SUBJECT: TECHNICAL SPECIFICATION AMENDMENT TO PERMIT RELOADING  
 AND OPERATING PEACH BOTTOM, UNIT 2, FOR CYCLE 7

PEACH BOTTOM ATOMIC POWER STATION, UNIT NO. 2

Amendment No. 108  
License No. DPR-44

SAFETY EVALUATION BY THE OFFICE OF NUCLEAR REACTOR REGULATION SUPPORTING  
AMENDMENT NO. 108 TO FACILITY OPERATING LICENSE NO. DPR-44

FIGURE 3.5K2 MCPR OPERATING LIMIT vs  $\gamma$

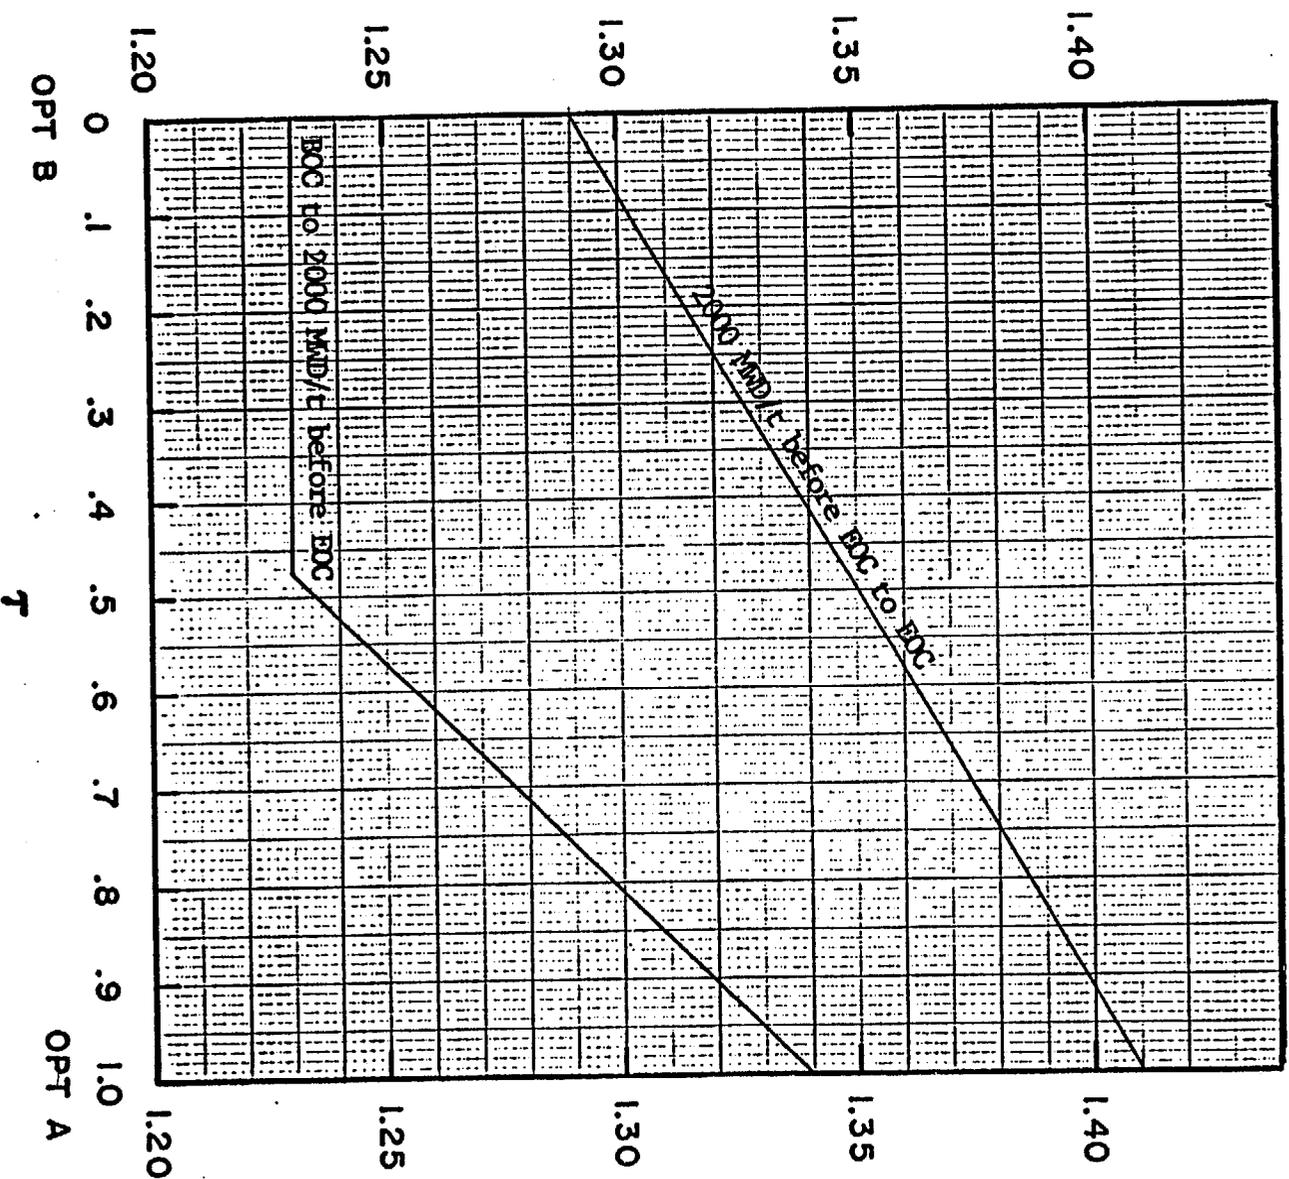
### 2.5.3 OLMCPR Values

The proposed Technical Specification values of the OLMCPR are conservative with respect to the values reported in Reference 1 and are acceptable.

FIGURE 3.5.1J MAXIMUM AVERAGE PLANAR LINEAR HEAT GENERATION RATE VERSUS PLANAR AVERAGE EXPOSURE

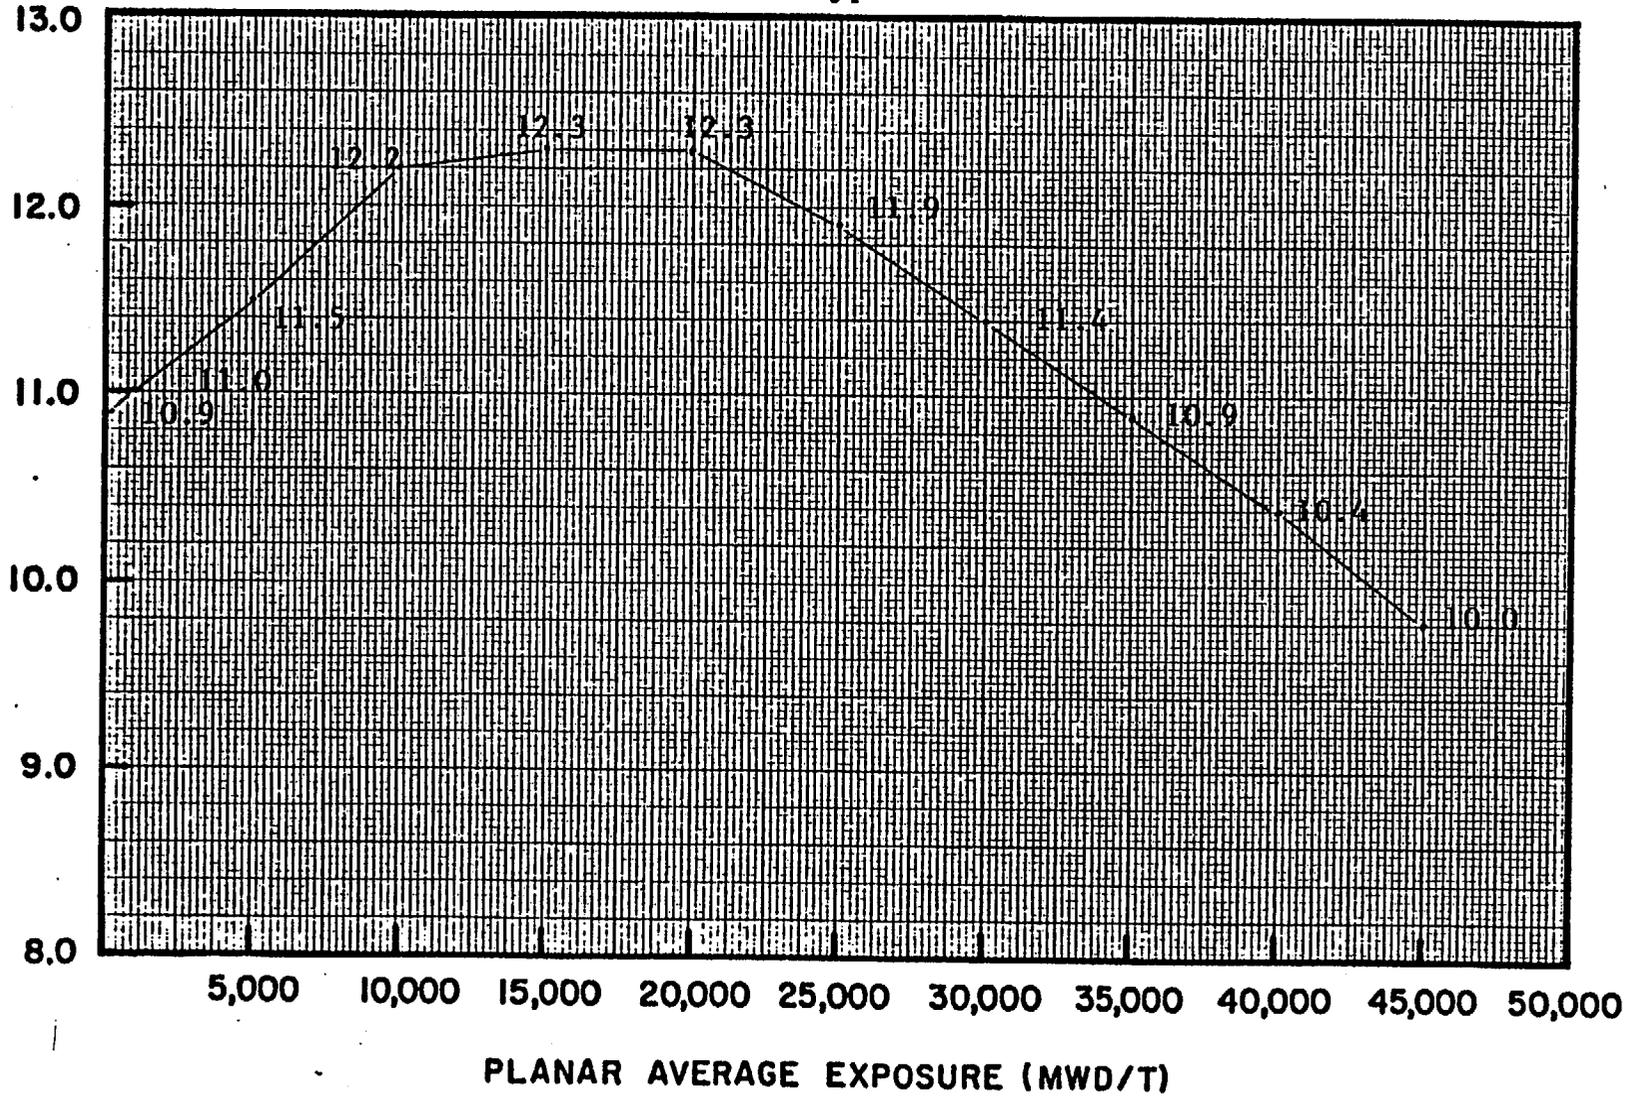
### 2.5.4 MAPLHGR Limits for New Fuel

The MAPLHGR limits in the Technical Specifications are consistent with those given in Reference 2 and are acceptable.
